MECKLENBURG COUNTY HEALTH DEPARTMENT

APPLICATION FOR PERCOLATION TEST

SUBJECT: Lynn Avenue, Lot 17
APT #6107 (Ross Co., Ltd.)

SITE DISAPPROVAL REPORT
INDIVIDUAL SEPTIC TANK SYSTEM WITH SUBSURFACE, SOIL ABSORPTION, EFFLUENT DISCHARGE

7) ACCURATELY DIAGRAM & DIMENSION LOT

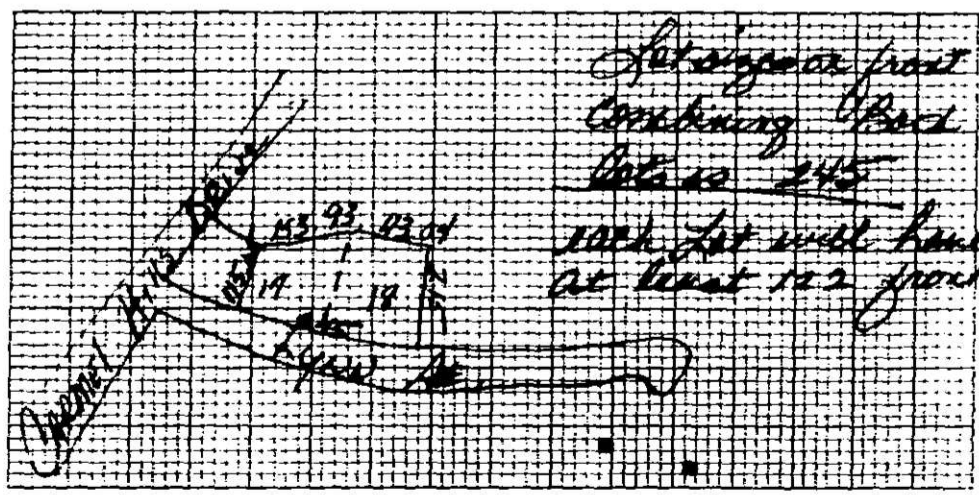
8-8-73 Soils are of the Wilkes and Iredell soil series. These soils have very plastic and sticky clay subsoils which contain swelling clay minerals. The Iredell soils also have a perched high water table during periods of high rainfall. The Wilkes soils are shallow to impervious rock material. These factors result in inadequately slow perc. and permeability. Based on these observations, disapproval is recommended.

FAILURE TO PASS PERCOLATION TEST (60 minutes per inch or less)

Test No.	Date of Test	Percolation Rate
X	1.	6-6-73	250 min/in
X	2.	8-7-73	120' min/in
X	3.	10-24-73	160 min/in
